UNITED STATES PATENT AND TRADEMARK OFFICE

APPLICATION NO.	FILING DATE	FIRST NAMED INVENTOR	ATTORNEY DOCKET NO.	CONFIRMATION NO.
09/398,652	09/17/1999	WILLIAM A. SAMARAS	042390.P5120D	1359

Office Action Summary

DETAILED ACTION

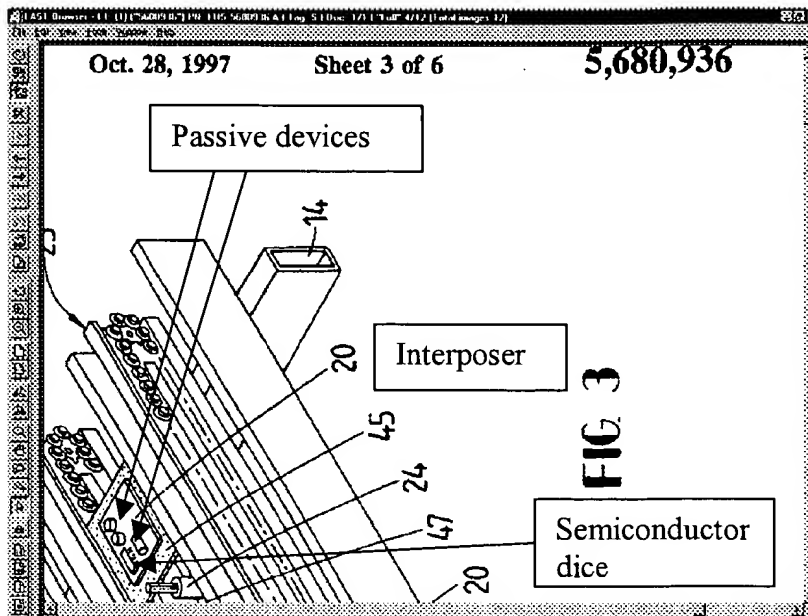
Beers discloses coupling at least one passive device (see annotated Fig. 3 below) thereby regulating voltage and current to the electronic dice.

Sakemi discloses not coupling solder balls to non-selected locations (where marked BM) thereby saving production cost.
